# Japan Position on OICA Comments @GRPE#85 on GTR 21

16. February.2022

Figure 25  
Example of power determination reference points R1 and R2 for a simple parallel architecture.

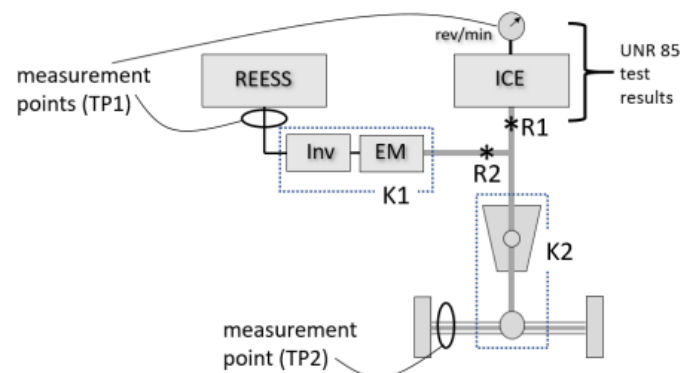
Since the definition of the reference point (\*1) in the GTR 21 indicated TP1 and TP2 should be equivalent in principle.

- 1) The difference between the results of TP1 and TP2 is due to the accuracy of K1 (inverter + motor efficiency) and K2 (transmission efficiency).
- 2) Validation test requires that test methods should be clearly defined, but there is no standardized measurement method of the transmission efficiency.
- 3) In the power split type of the HEV system with Planetary gears, K2 cannot be measured.

As a solution, TP1 and TP2 were defined to be equivalent by defining reference points R1 and R2.

Even for vehicles not in the matrix, if the HV system configuration is known, R1 and R2 can be clearly defined and no further validation tests are necessary.

Figure 26  
**Example of power determination reference points R1 and R2<sub>REESS</sub> for a simple power split architecture.**

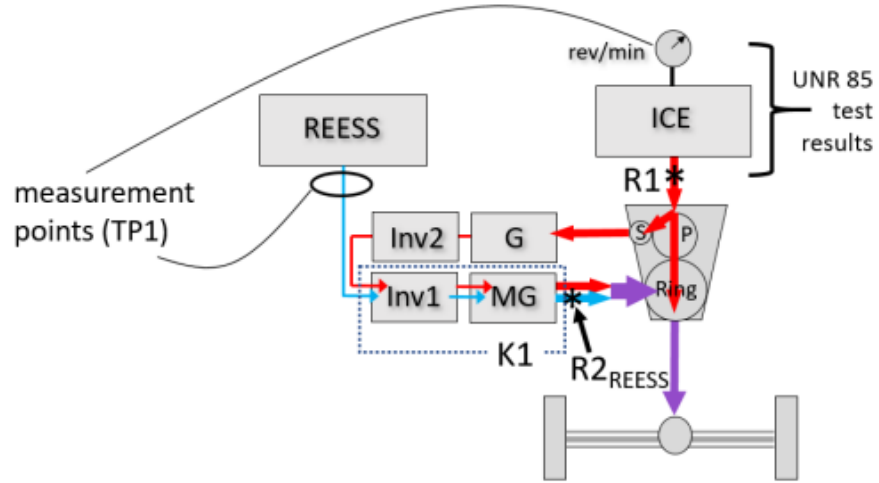
Since K2 of power split HV with planetary gear cannot be measured, GTR21 indicated TP2 is not applicable and TP1 can be used. (Validation studies comparing TP1 and TP2 cannot be conducted.)

Reference points of a simple power-split HV or series HV is defined above.

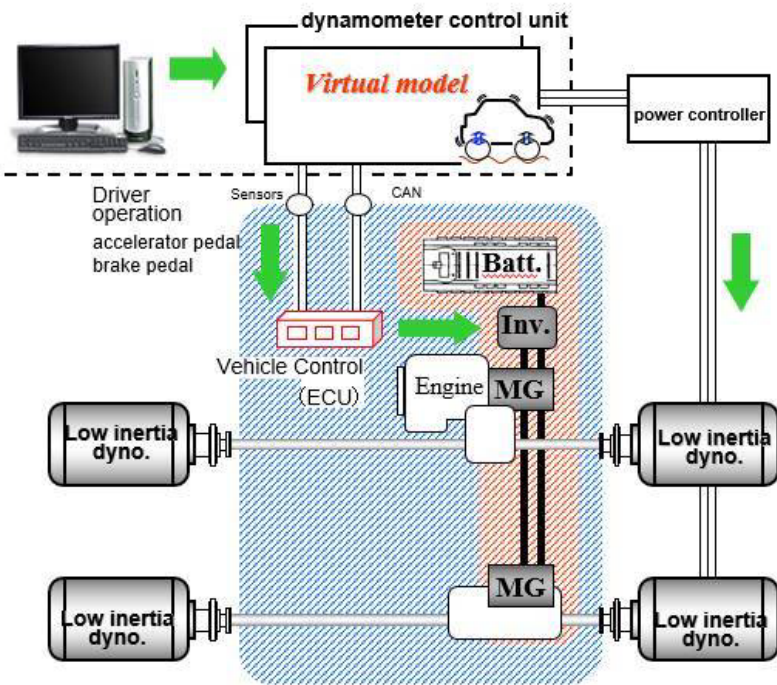
We propose to revise GTR21 so that both TP1 and TP2 can be carried out by not only chassis dynos or Hub dyno, but also “ System bench”.

1. There is a possibility of products with very powerful HV (or BEV with multiple motors) that cannot be measured by normal chassis dynos because of reasons mentioned above.
2. TP1/TP2 can be measured by Hub Dyno, but Hub Dyno is expensive and has limited usage opportunities.
3. It is desirable that the system bench, which has been used in the development by each company, is an option for carrying out TP1 and TP2.

Each powered axle that provides propulsion under the maximum power condition shall be tested by chassis dynamometer hub dynamometer **or system bench.**

Vehicles that are powered by two powered axles under the maximum power condition shall be tested by four-wheel-drive chassis dynamometer, or each powered axle shall be tested simultaneously by hub dynamometer **or system bench.**
